**Subject:** ADDENDUM # 1

**Harding Lawson Associates**  
 Engineering and Environmental Services  
 3 Hutton Centre Drive, Suite 300  
 Santa Ana, CA 92707 - (714) 556-7992

**ADDENDUM NO. 1**  
**UTILITY TRAILER MANUFACTURING COMPANY**  
**11/14/84**  
**INTERIM VAPOR RECOVERY TRENCH INSTALLATION**  
**AND TREATMENT PILE CONSTRUCTION**

Utility Trailer Manufacturing Company City of Industry, California	<b>TREATMENT SYSTEM LAYOUT AND PIPING AND INSTRUMENTATION DIAGRAM</b>	SHEET: <b>G-2</b> OF: <b>4 of 6</b> REVISION NUMBER: <b>0</b> DATE: <b>11/84</b>
---	---	---

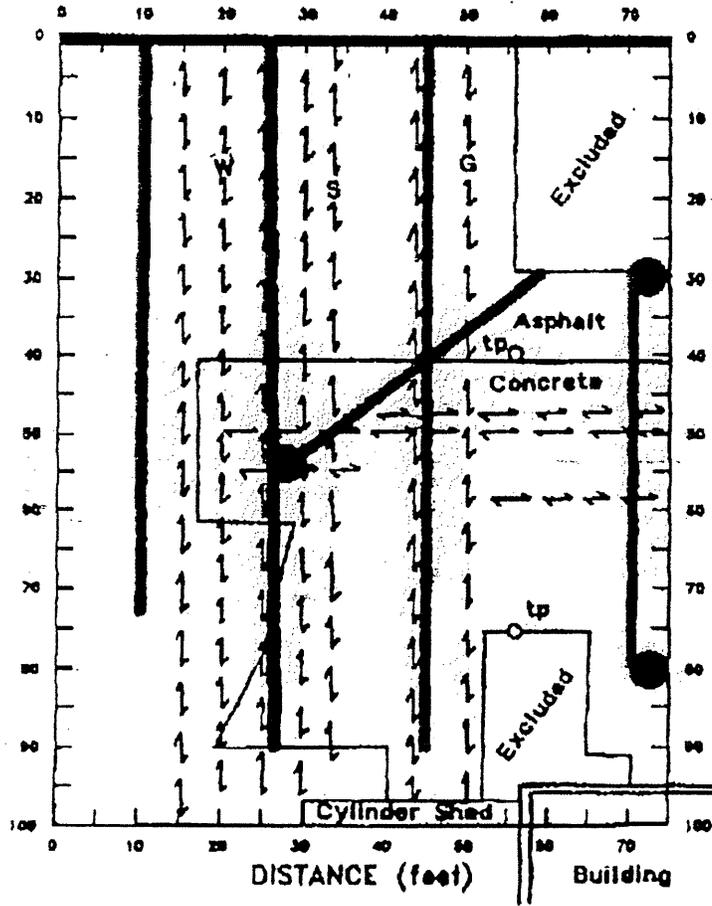
17. The Subcontractor shall be responsible for supplying and installing three pressure indicators as shown on the process and instrumentation diagram for the vapor recovery trenches. These pressure indicators are to be 0 to 100 inches.

18. Attached is a portion of Drawing C-2; the Subcontractor shall exclude any work shown in the shaded area. Two 4-inch valves upstream of the manifold detail shall be installed by the Subcontractor along with the 4-inch vent stack as shown on the plans.
